**TOWN OF SUMMERVILLE
COMMERCIAL DESIGN REVIEW BOARD – AGENDA
Summerville Municipal Complex
Annex Building 2nd Floor Training Room
June 15, 2017 4:00 p.m.**

**STAFF REPORT
CDRB Meeting
June 15 at 4:00 p.m.**

SHEET TITLE:
SITE PLAN

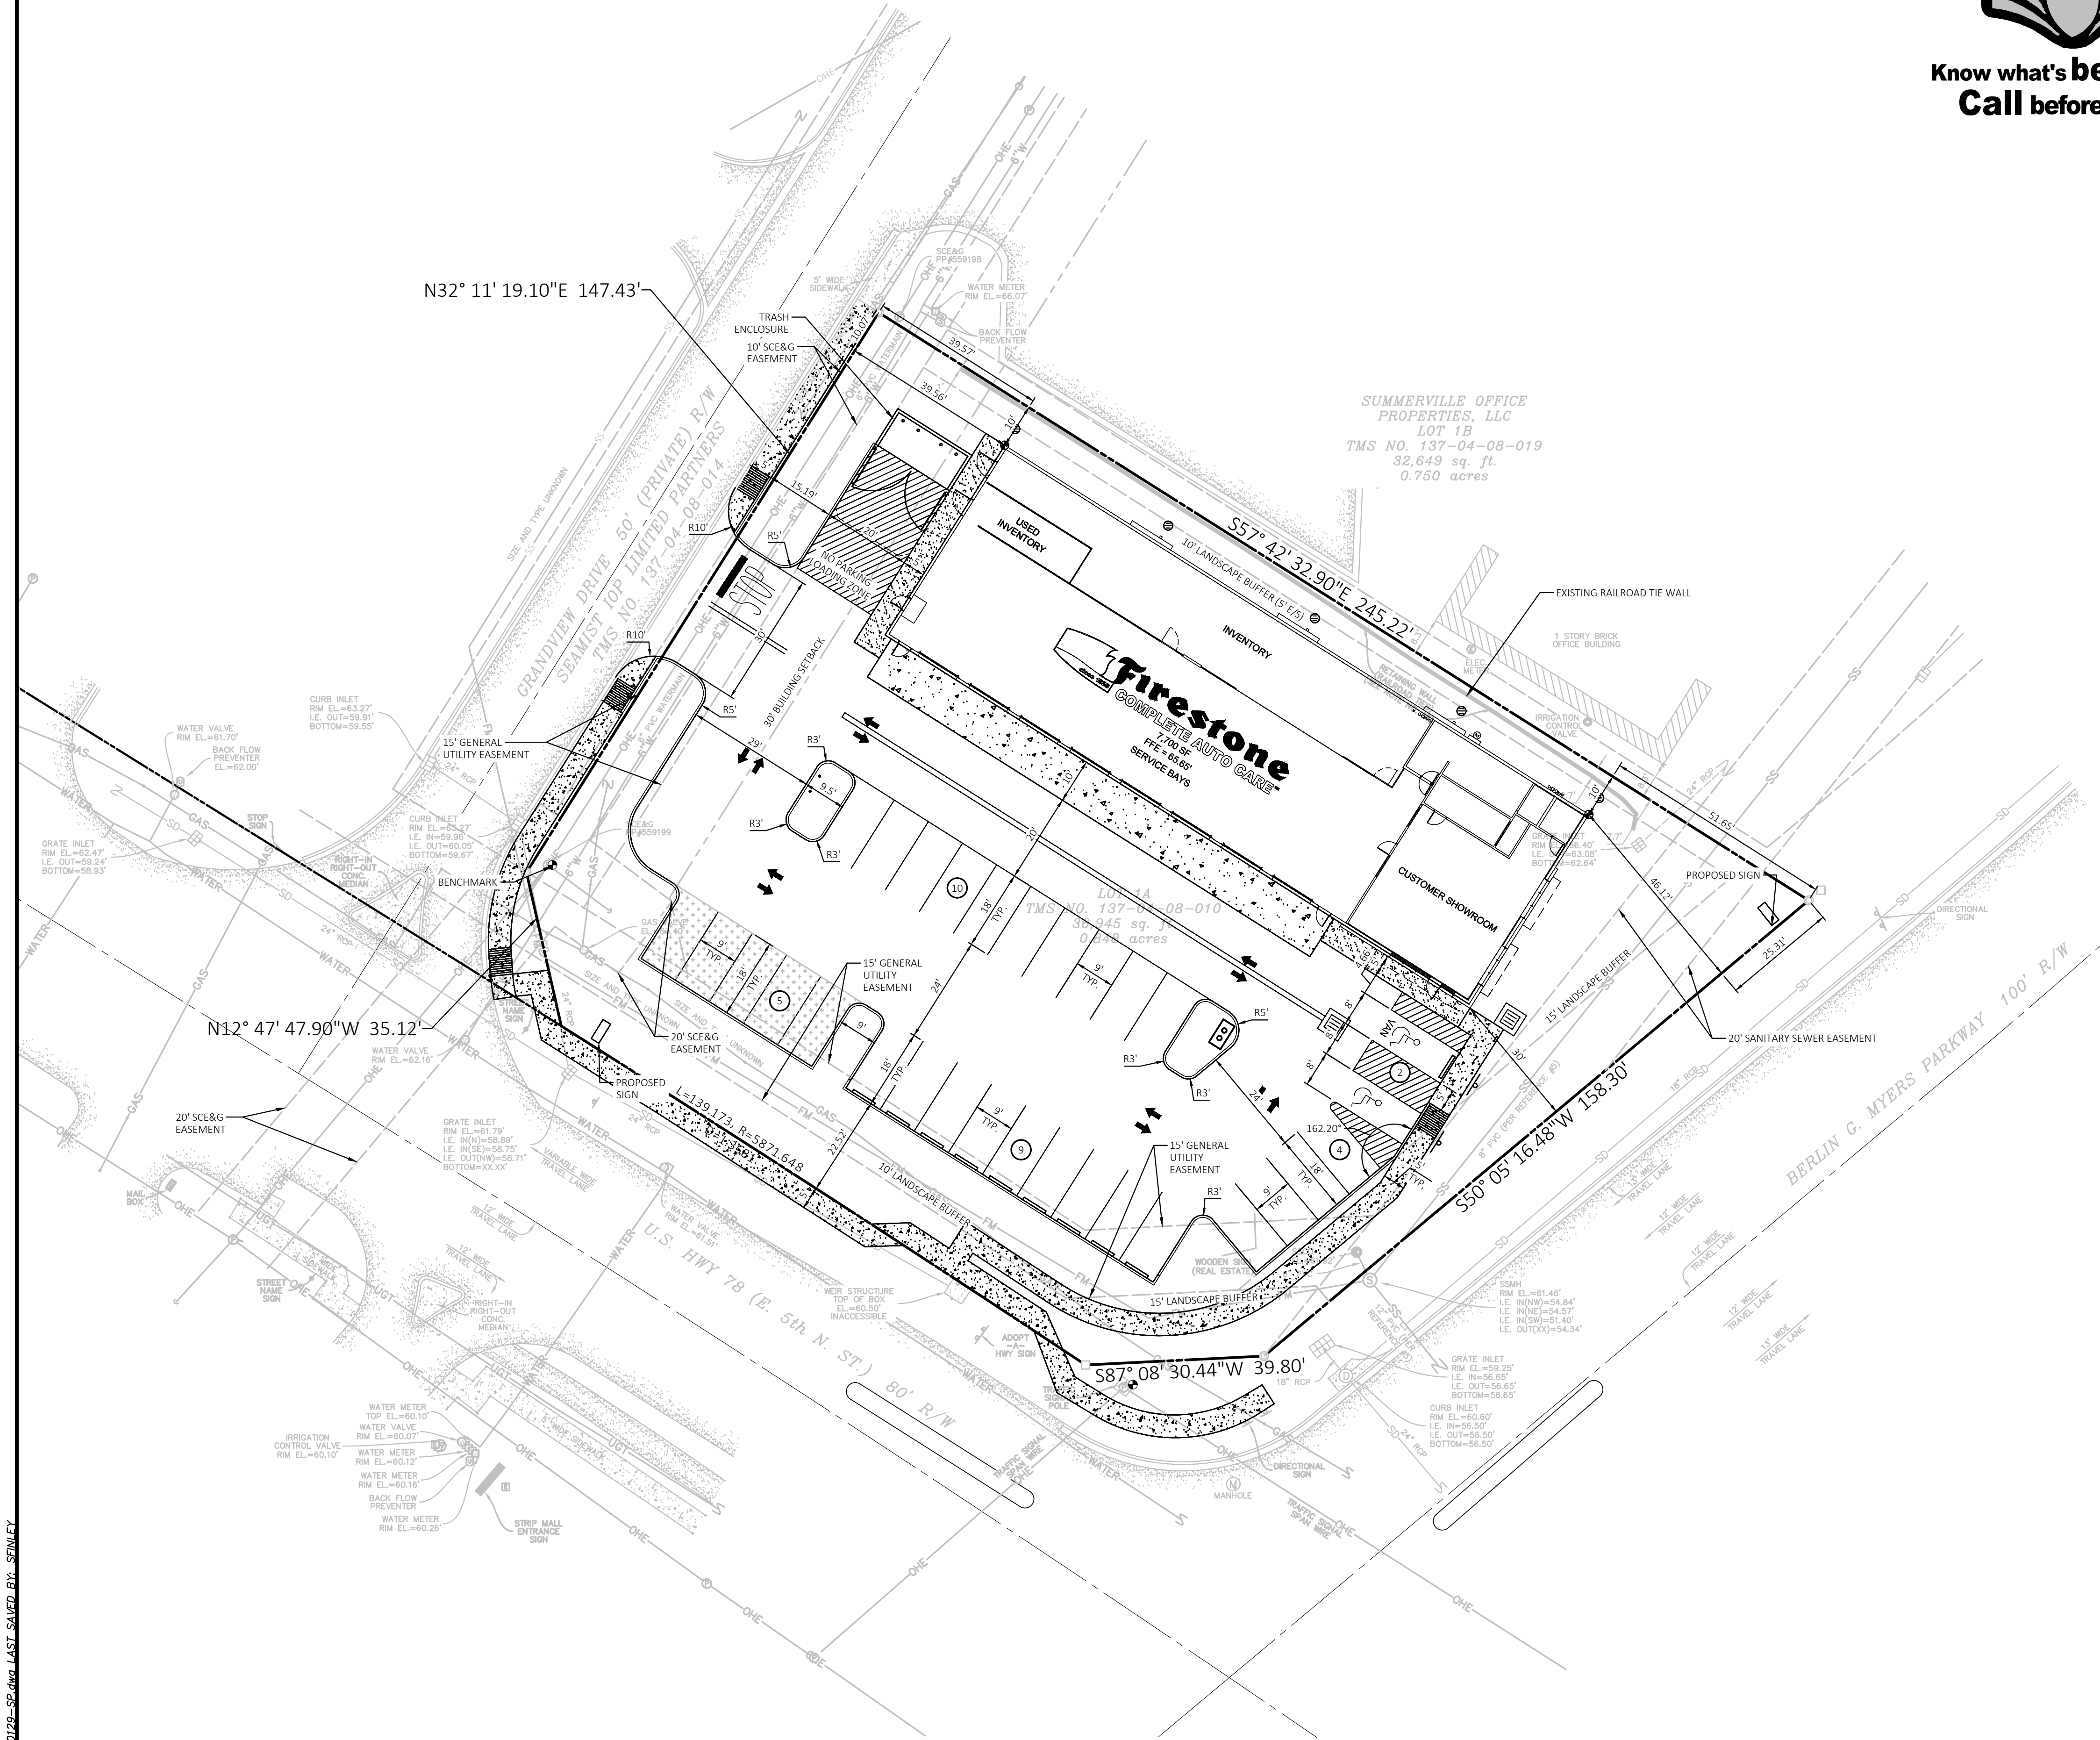
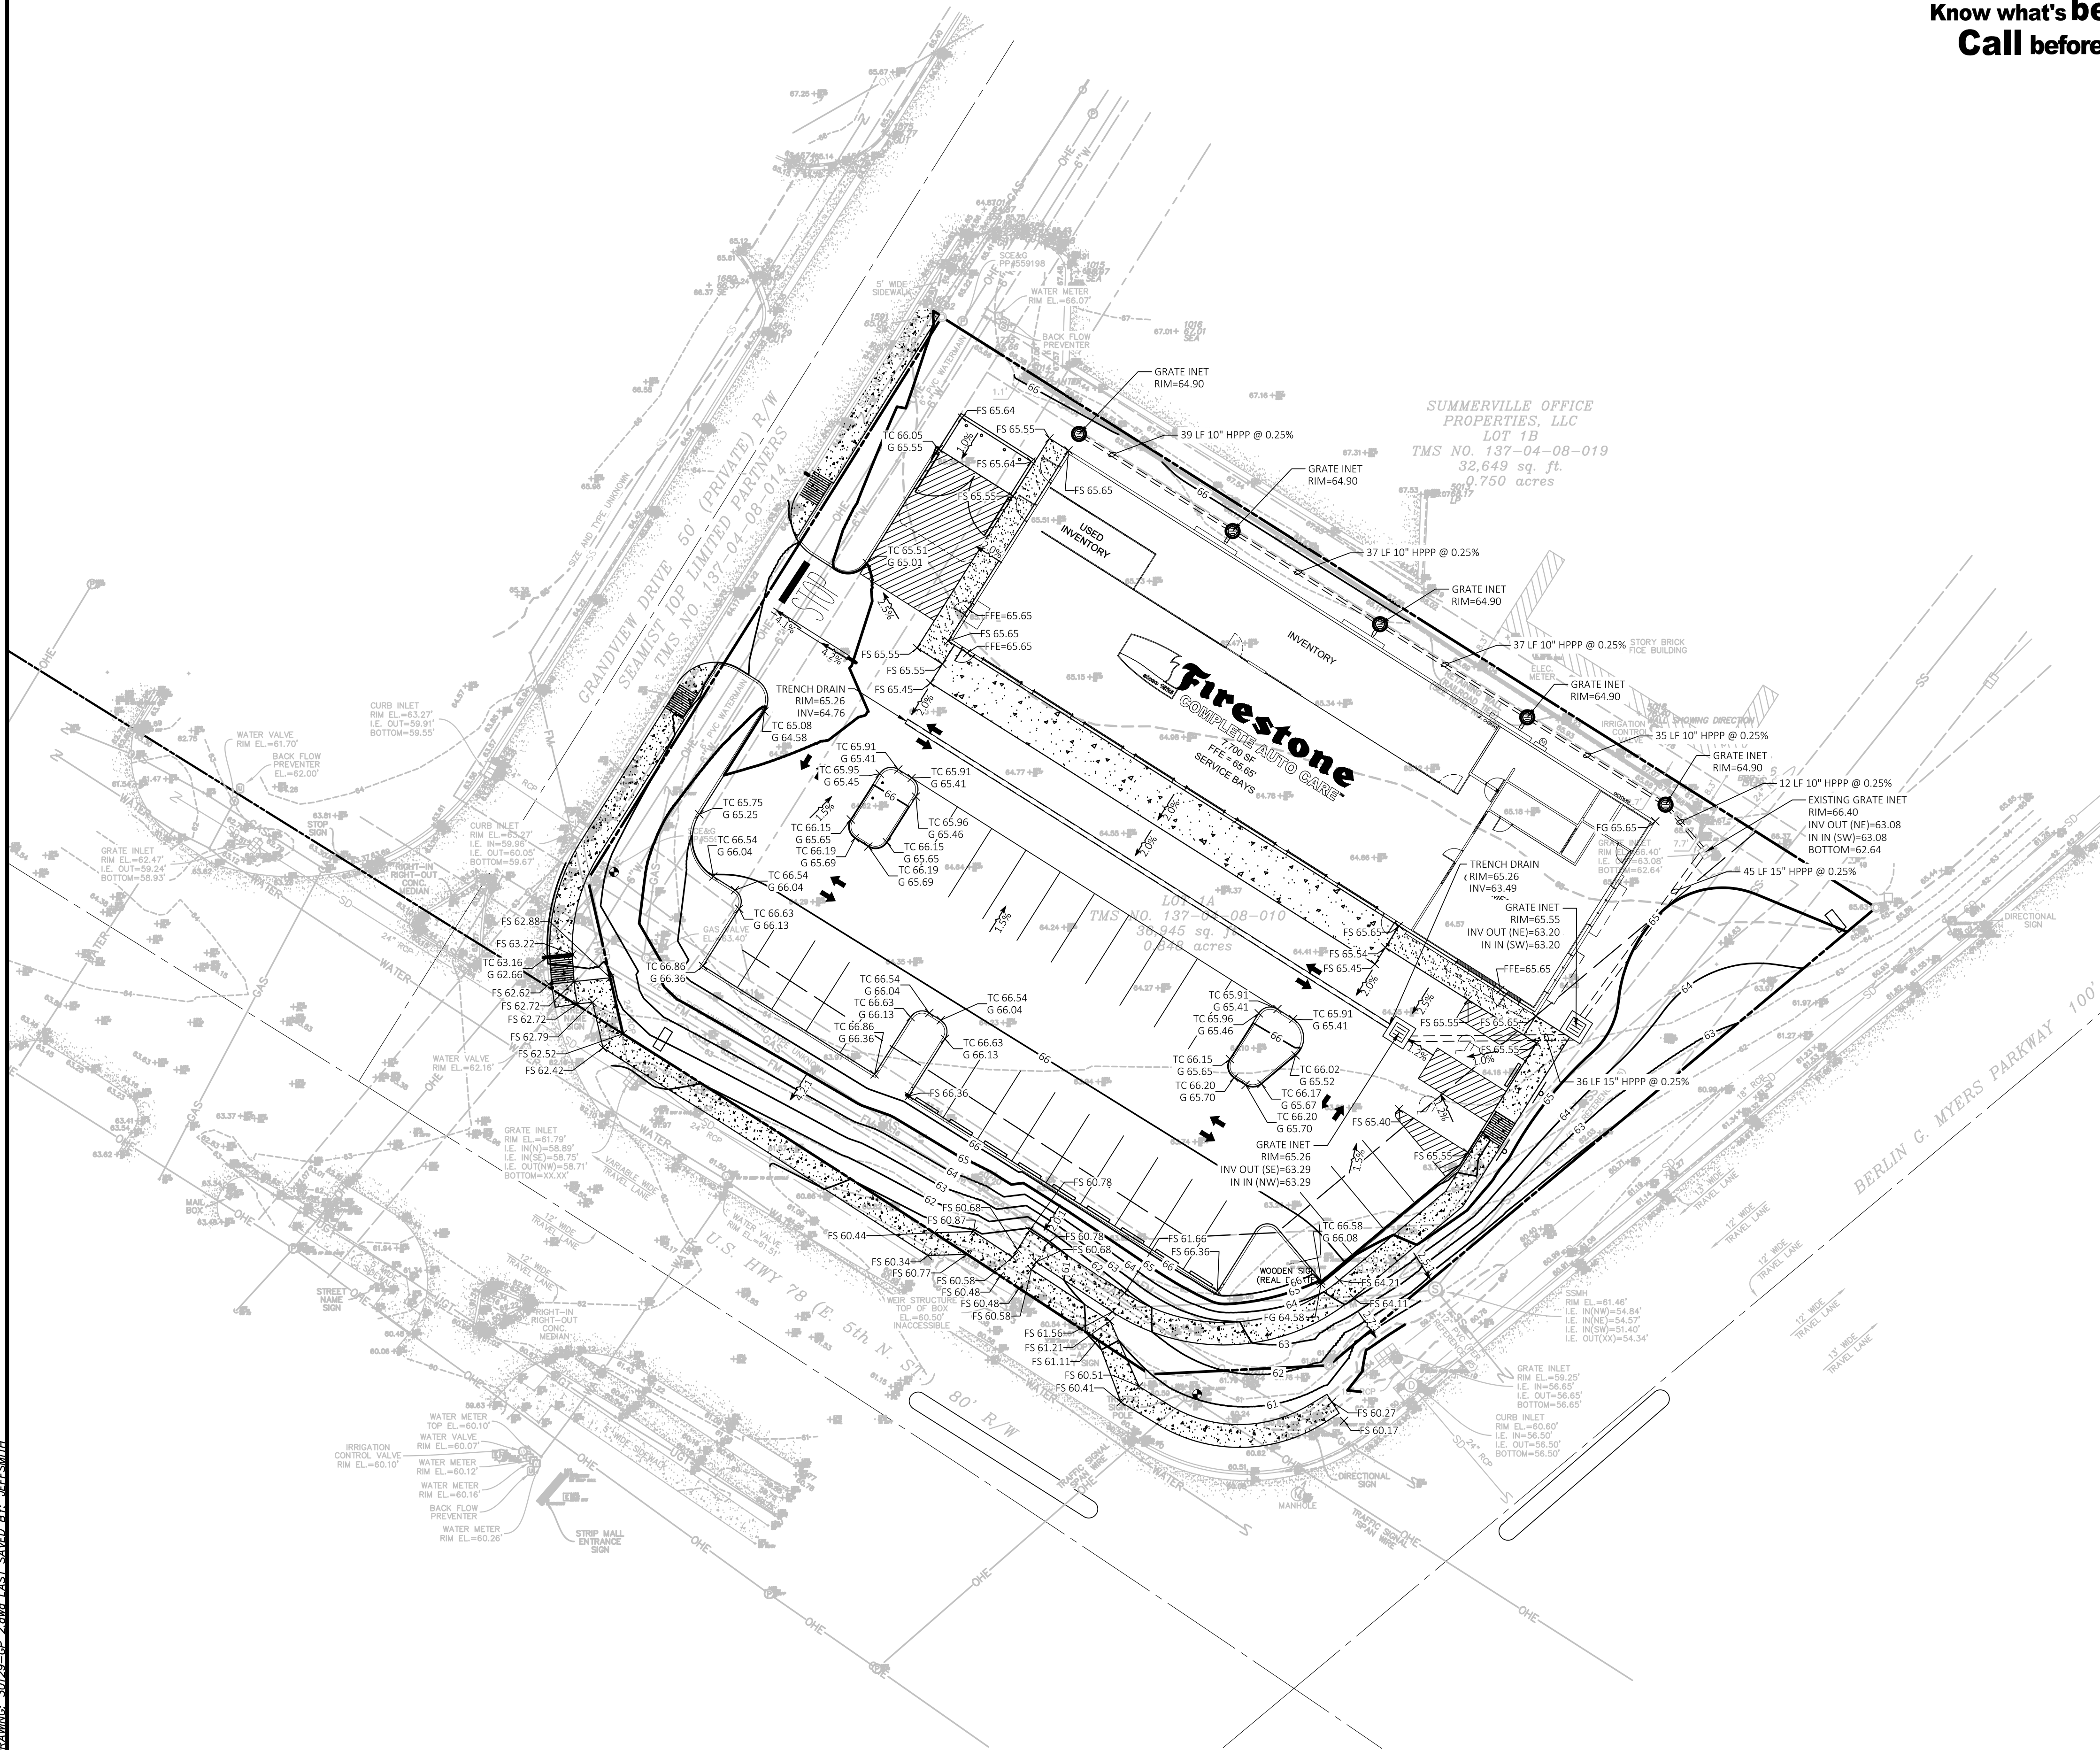
The plan is showing 30 parking spaces, based on staff's calculations only 23 parking spaces are required. Section 32-291 (a) requires that all parking over the minimum should be constructed with pervious materials. The plans are only showing 5 pervious parking spaces. A parking justification letter has been submitted addressing why the need for additional parking as well as the use of the facility. The applicant must also provide proof that permission has been granted for the parking encroachments shown on the plan and staff has not been notified of this to date, the applicant is working with the appropriate utility companies. All parking lot islands now meet the minimum allowed square footage of space. A dumpster location is now indicated on the proposed plan but no screening design has been submitted. The fire department connection and the sprinkler riser room is now located on the front of the building. Per Engineering's comments all sidewalks must be within the right of way, not on private property. The applicant should coordinate with SCDOT to get encroachment permits for sidewalks. Handicap accessibility is needed at the corner of Berlin G. Myers Parkway and Highway 78 and reconfigured so that it will terminate to Highway 78 and Berlin G. Myers Parkway into a potential crosswalk. Right angle jogs in the sidewalk are not recommended, the applicant will need to work with the Engineering Department to determine best route. Landscaping requirements are not met based on the location (front and side borders) and species called out on the plans. Permission may be needed from the utility companies to plant trees within their easements, applicant will verify this as there are several General Utility lines shown on the plans. The lighting plan is meeting the average allowed but is towards the upper end with an average of 2.95 lumens. All lighting appears to be shielded per the lighting package. Awnings have been added over the bays per the board's request. Monument sign location does not meet ordinance requirements of 10' off right of way; easement restrictions have limited the location. Other signs appear to meet zoning ordinance requirements. Since it is an auto repair establishment, it is excluded from the required bicycle parking space requirement.

I am writing this letter in response to the phone conversation we had yesterday regarding the parking ratio for our proposed Summerville, SC facility. I am writing to request an increase in the allowable parking provided on this site for 2 reasons. First, the actual building area that should be included in the parking ratio calculation should include our Inventory Room which is integral to the operation of our Service Bays. This is not a static storage room, and in our more current prototype models the partition separating the Inventory Room from the Service Bays has either been removed or lowered to a 4'-0" high half partition (mainly used to run electrical conduit through the stud cavity to power our technician's equipment chargers). The second reason for this parking increase request is our very business model requires a minimum of 30 parking spaces for our stores to profitably function.
